Approved Section 4.55 (2) Modification Application

No: SSD 6966 MOD 1 Granted on 19 August 2021

ONE SYDNEY HARBOUR

BARANGAROO

1 Opaque Cladding - Elevation
1:25

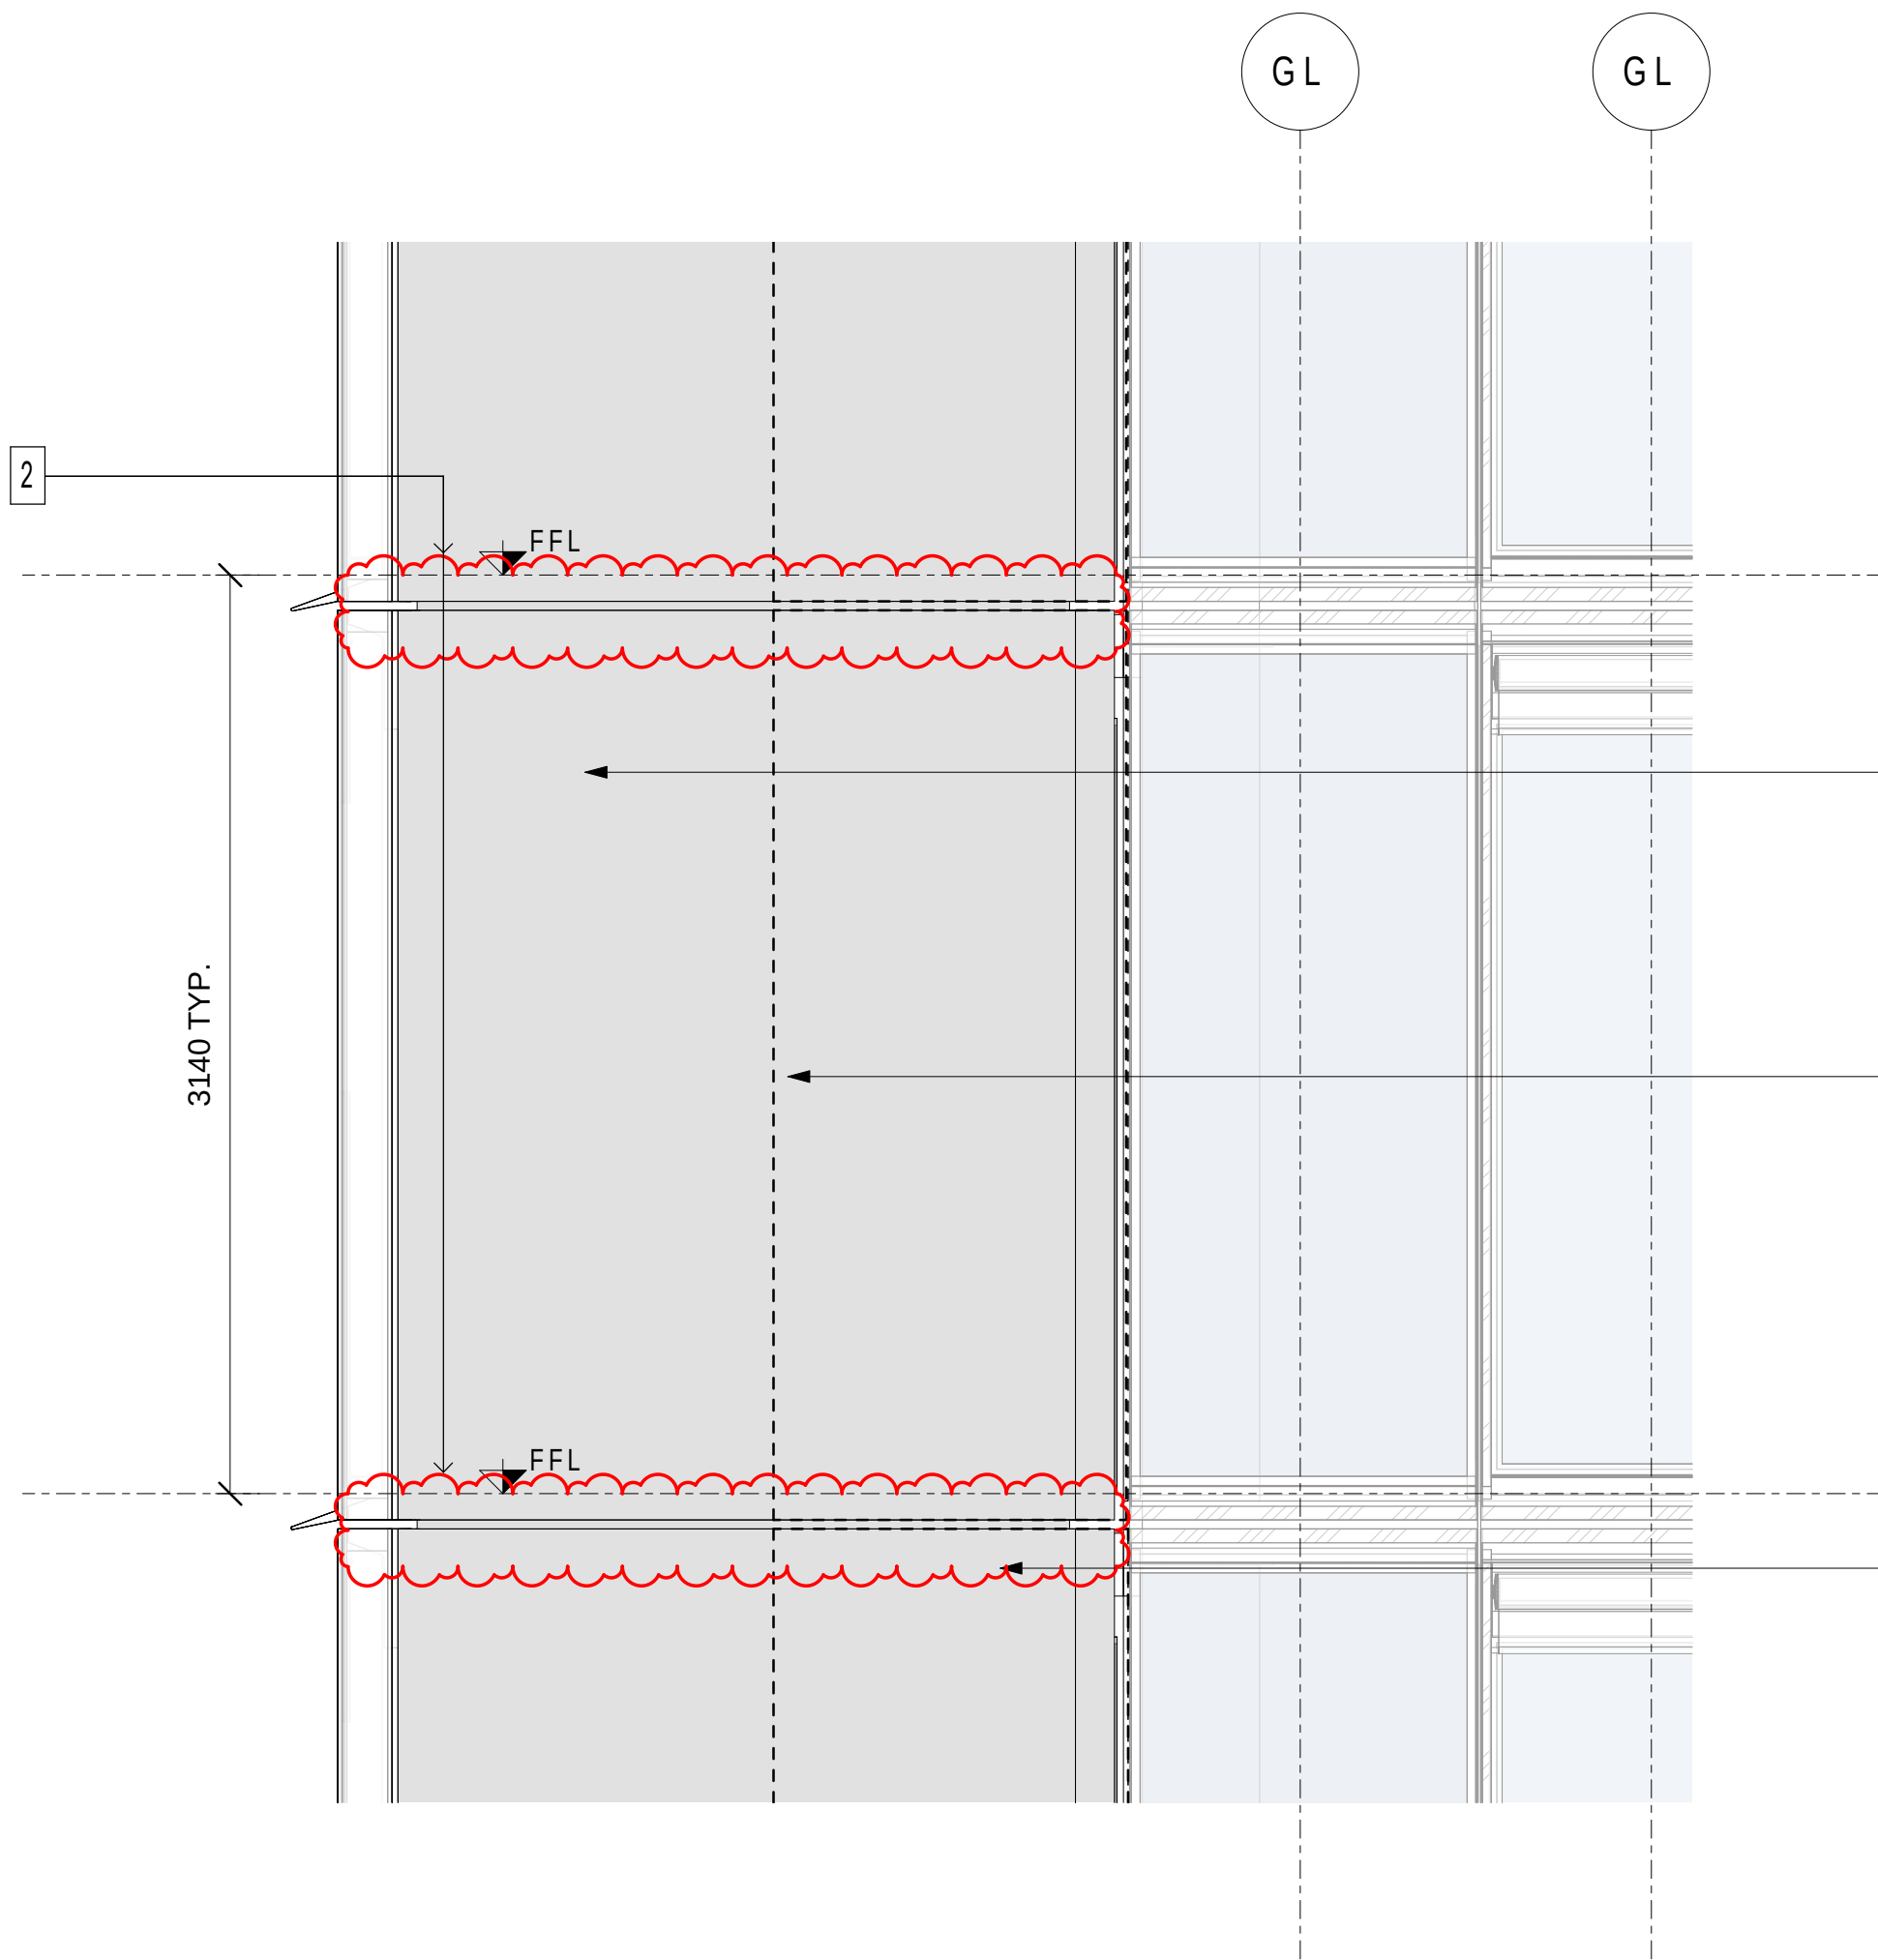
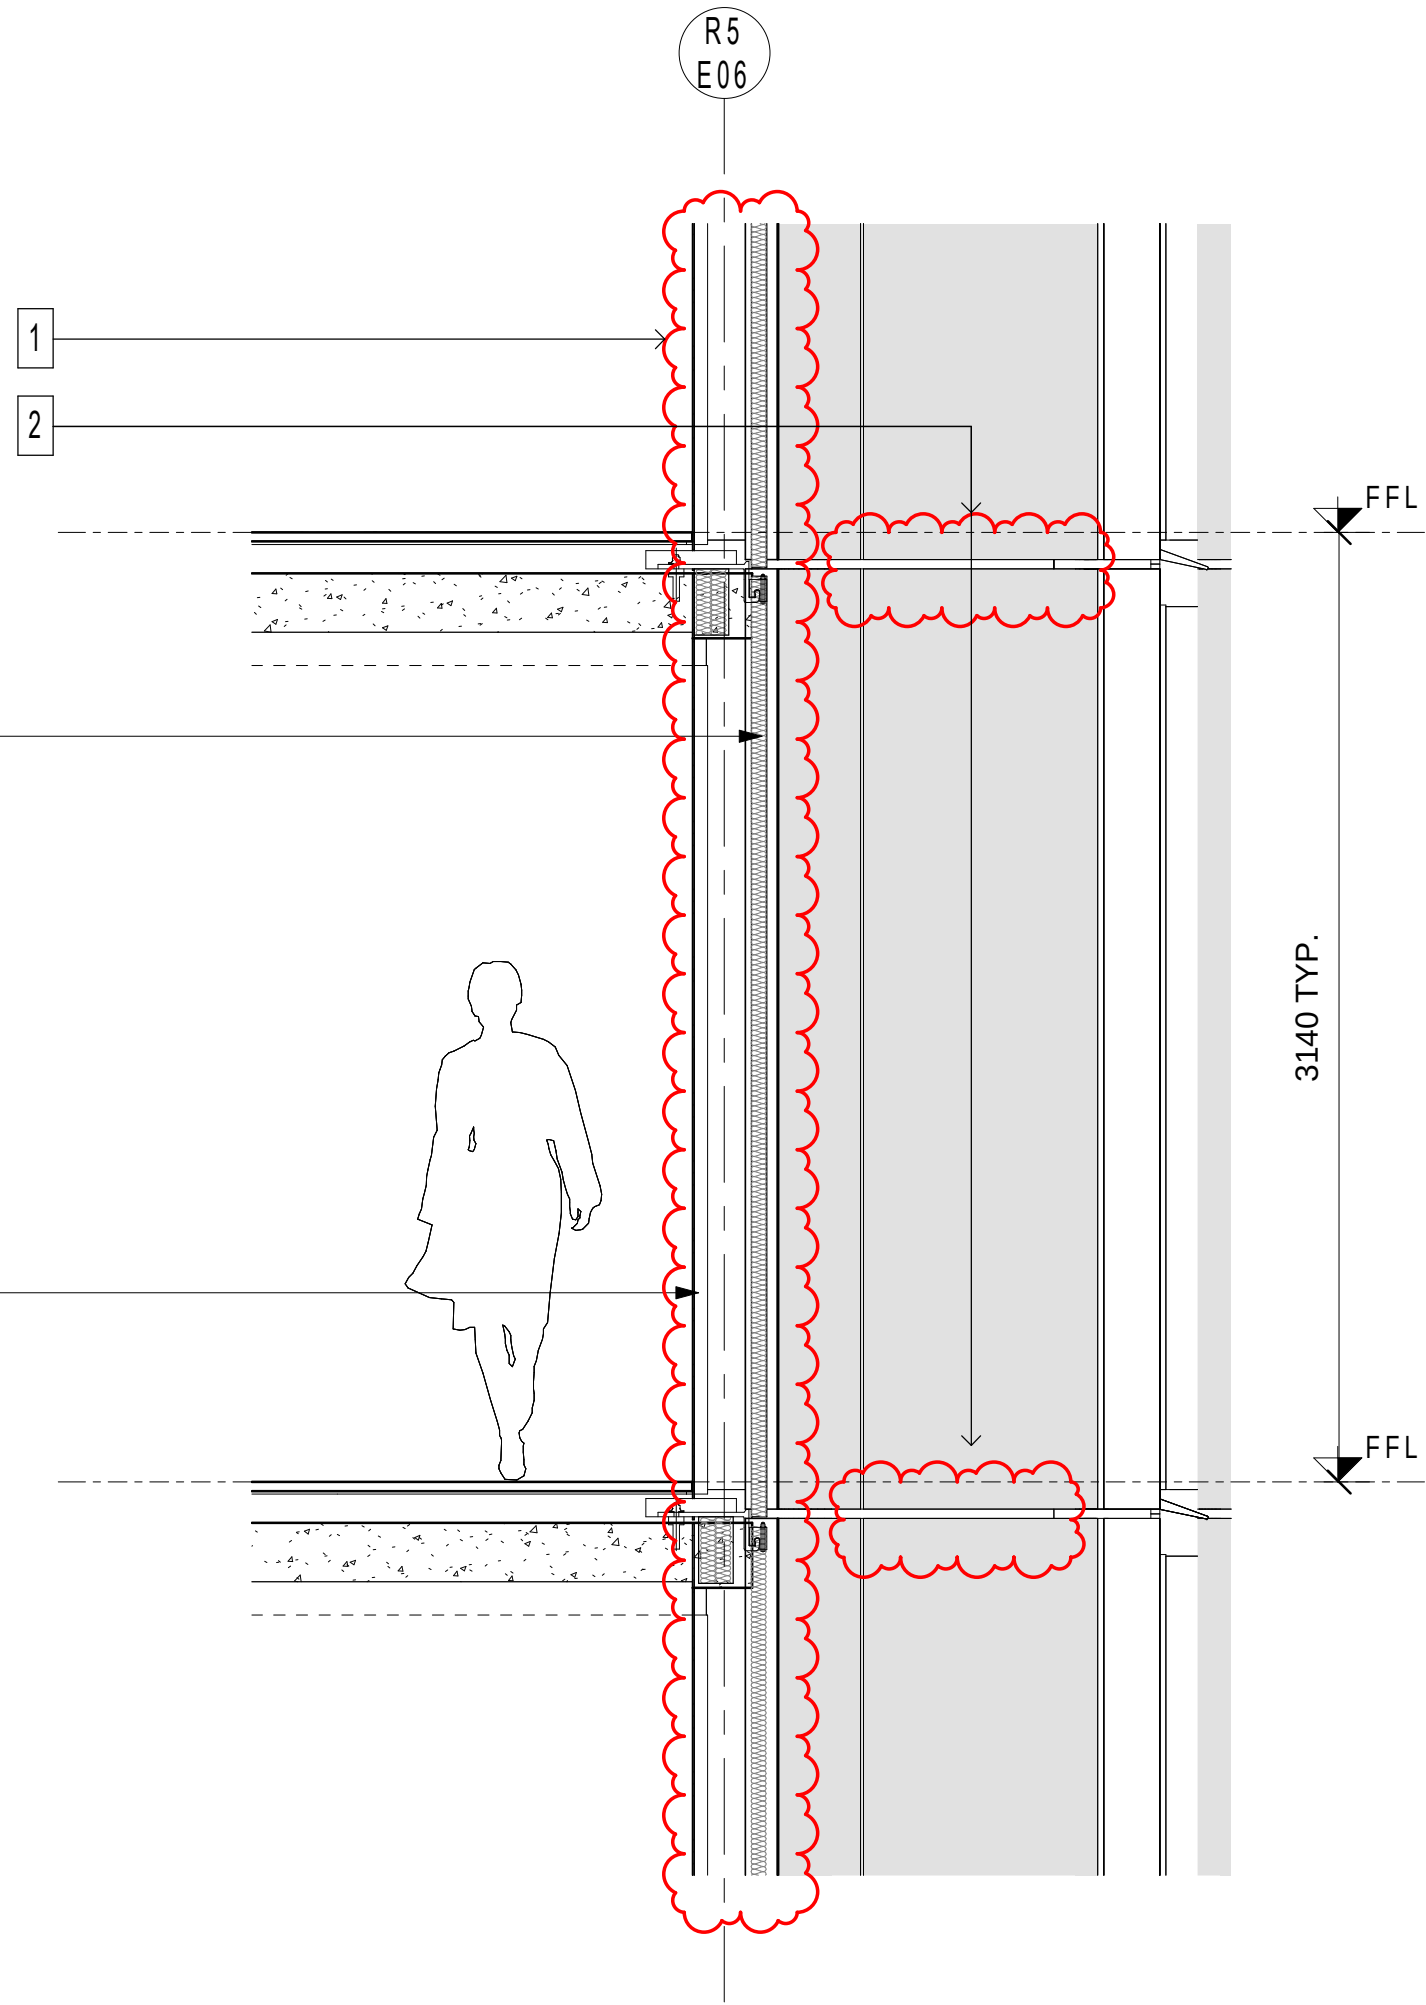
1. UPDATED CLADDING BUILT-UP
2. REMOVED CLADDING HORIZONTAL LIPS
